SUBJECT: ISSUANCE OF AMENDMENT NO. 18 TO FACILITY OPERATING LICENSE NO. NPF-38  
FOR WATERFORD 3

ISSUANCE OF AMENDMENT NO. 18 TO FACILITY OPERATING  
LICENSE NP. NPF-38 FOR WATERFORD 3

SAFETY EVALUATION BY THE OFFICE OF NUCLEAR REACTOR REGULATION  
SUPPORTING AMENDMENT NO. 18 TO FACILITY OPERATING LICENSE NO. NPF-38  
LOUISIANA POWER AND LIGHT COMPANY  
WATERFORD STEAM ELECTRIC STATION, UNIT 3  
DOCKET NO. 50-382

FIGURE 6.2-1  
ORGANIZATION FOR MANAGEMENT AND TECHNICAL SUPPORT

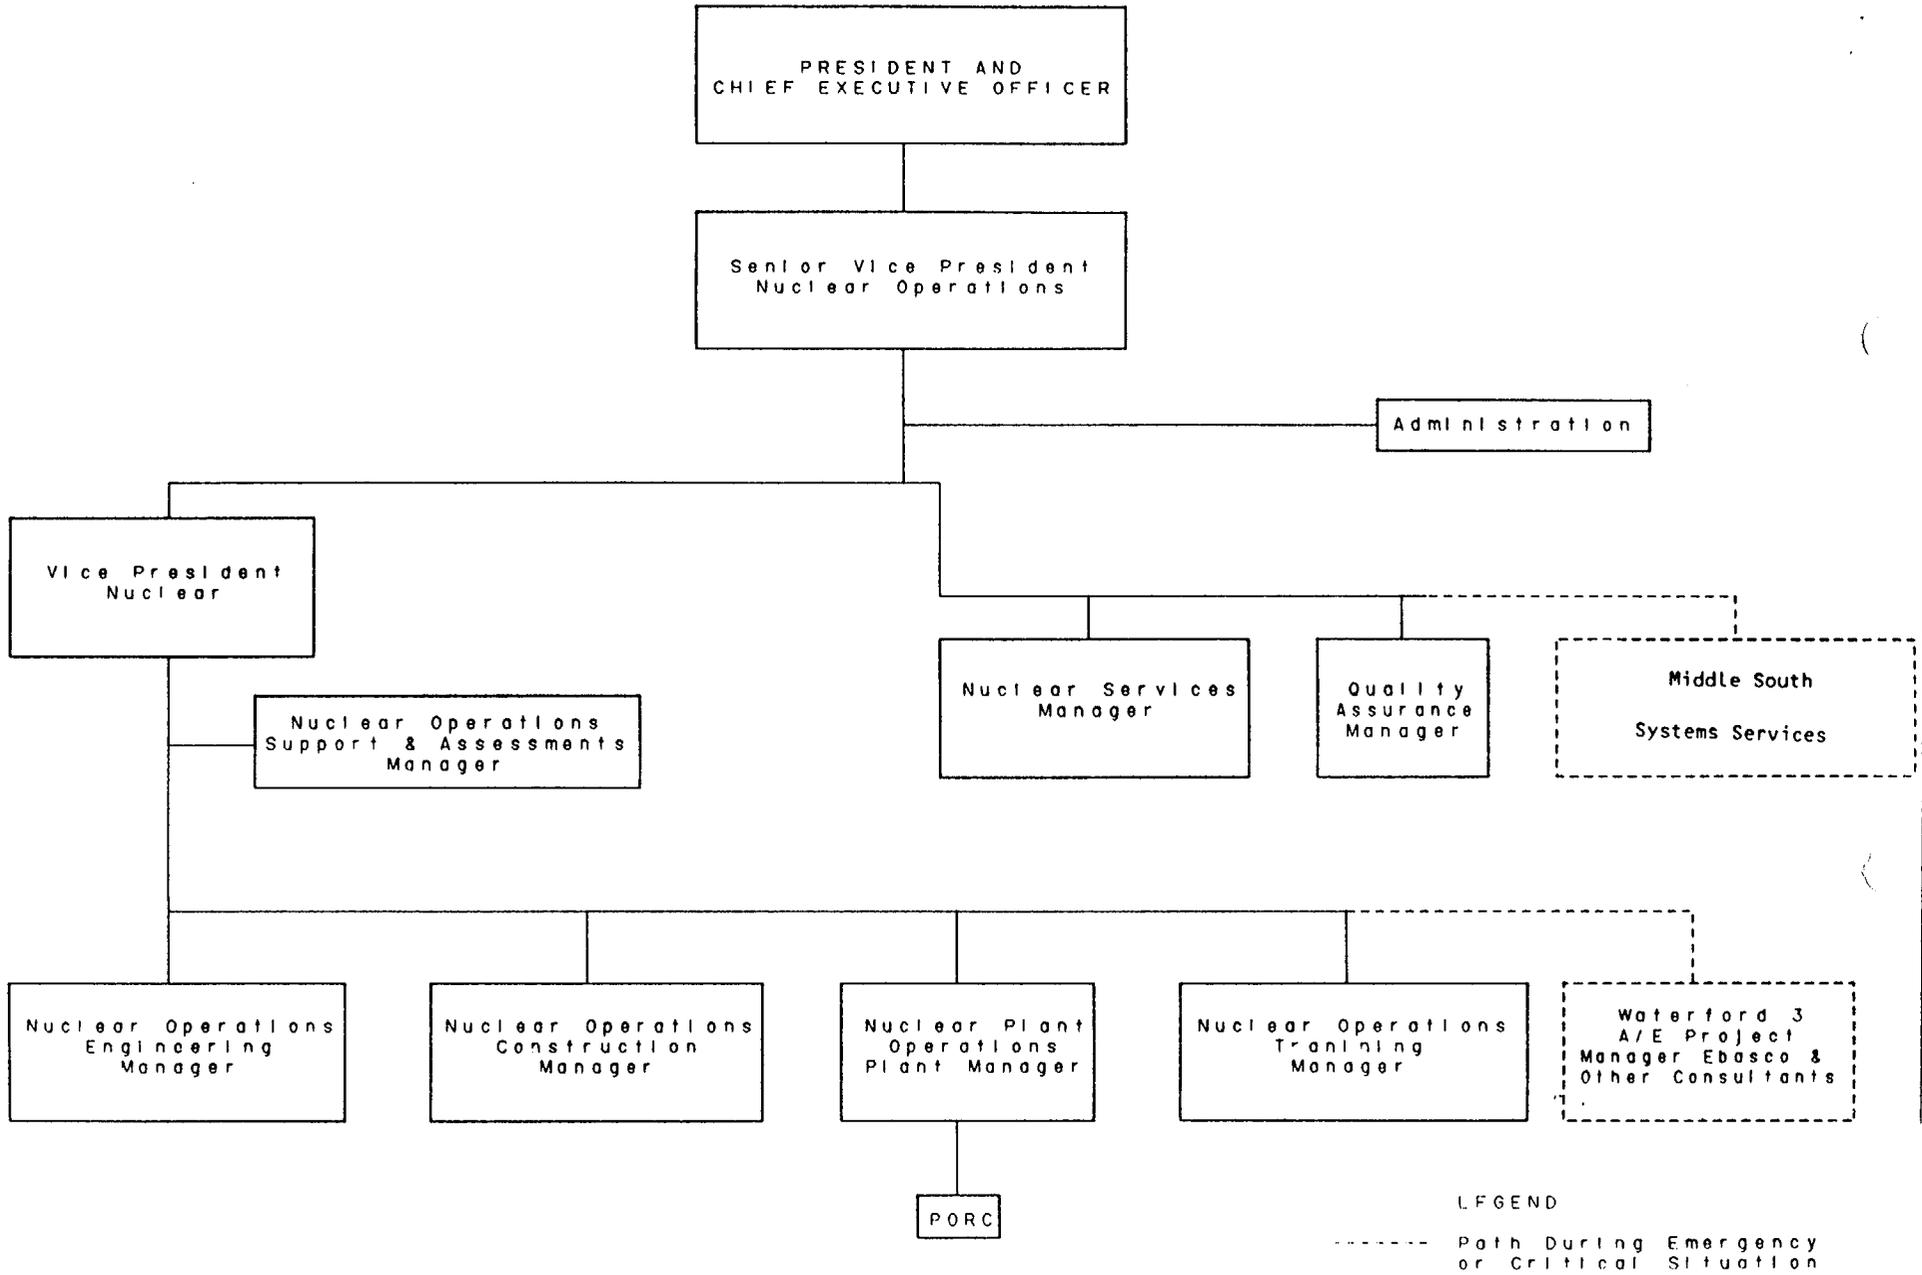
2.1 Figure 6.2-1 - Management Organization Chart

LP&L has revised the organization under the Senior Vice President-Nuclear Operations. These changes include the following:

- a) The new position of Vice President - Nuclear, who reports directly to the Senior Vice President Nuclear Operations, has been created. Reporting to the Vice President - Nuclear is the Nuclear Operations Engineering Manager, the Nuclear Operations Construction Manager, the Nuclear Operations Plant Manager, the Nuclear Operations Training Manager, and the Nuclear Operations Support and Assessments Manager.
- b) The position of Project Manager, who previously reported to the Senior Vice President-Nuclear Operations, has been deleted. The functional responsibilities of the Project Manager have been redesignated principally to the Nuclear Operations Engineering Manager and Nuclear Operations Construction Manager.

- c) The new position of Nuclear Operations Support and Assessment Manager, who reports to the Vice President-Nuclear, was created.

The staff has reviewed the changes to Figures 6.2-1 and 6.2-2 and has determined that they will enhance the effectiveness of the Senior Vice President-Nuclear Operations in that by delegating some of his responsibilities to the Vice President-Nuclear, his attention can be focused on activities related to important safety issues. In addition, the proposed plant operations organization still maintains clear lines of authority, through the Vice President-Nuclear to the Senior Vice President Nuclear Operations and responsibility for activities important to the safe operations of Waterford 3. The changes are therefore acceptable to the staff.

FIGURE 6.2-2  
PLANT OPERATIONS ORGANIZATION

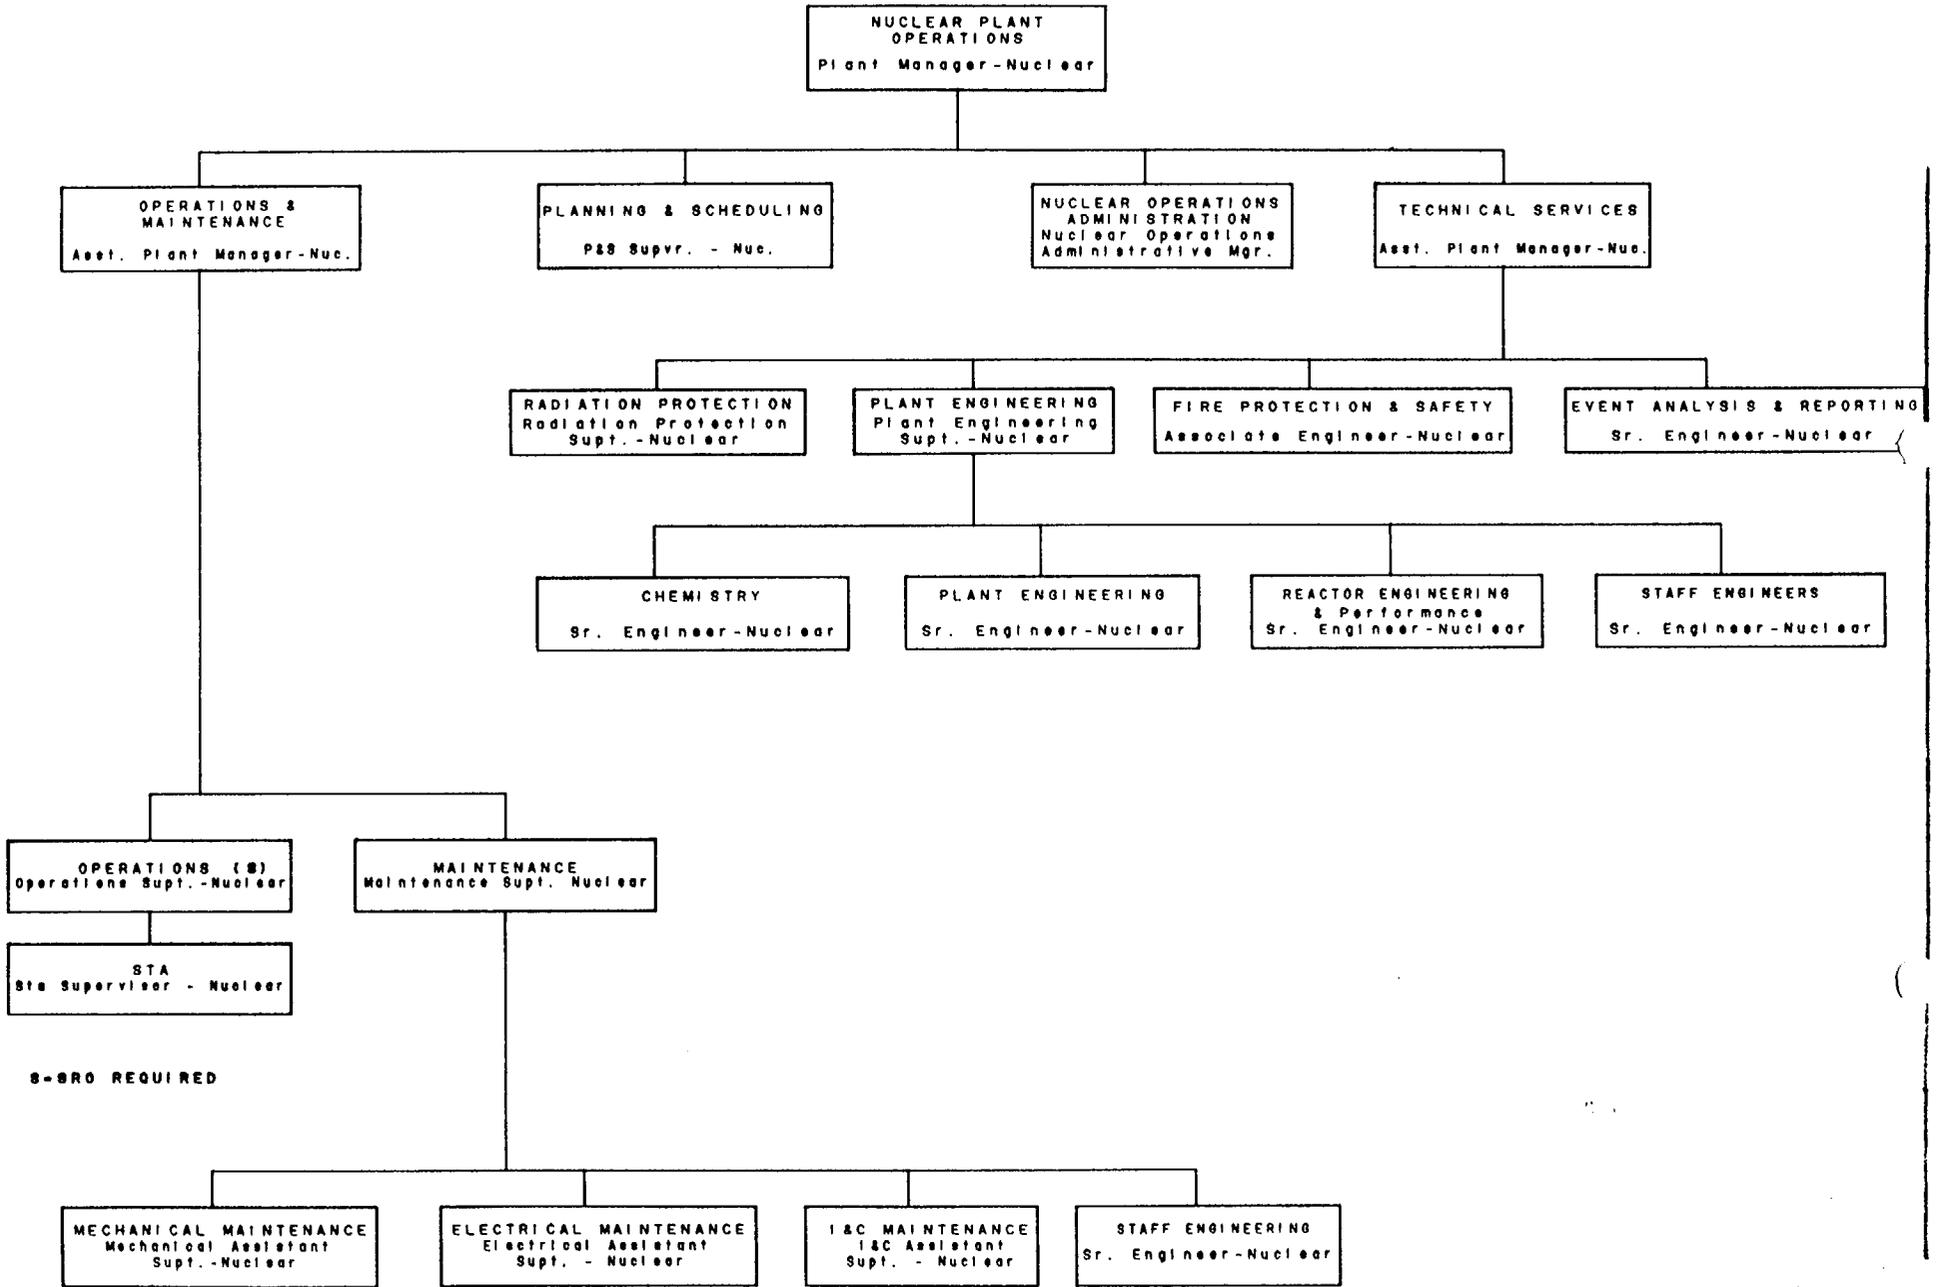
## 2.2 Figure 6.2-2 - Plant Operations Organization

LP&L has revised the plant operations organization for Waterford 3. The changes include the following:

- a) The STA supervisor, who previously reported to the Operations and Maintenance Assistant Plant Manager, now reports to the Operations Superintendent-Nuclear.
- b) The Plant Quality Group, which previously reported to the Plant Manager - Nuclear, has been consolidated with other Quality Assurance functions and now reports to the Quality Assurance Manager, who reports directly to the Senior Vice President-Nuclear Operations as shown in Figure 6.2-1.
- c) Two new functional areas, namely, Fire Protection Safety and Event Analysis and Reporting, have been established and report to the Technical Services Assistant Plant Manager.
- d) The Planning and Scheduling Supervisor who previously reported to the Assistant Plant Manager-Nuclear now reports directly to the Plant Manager-Nuclear.
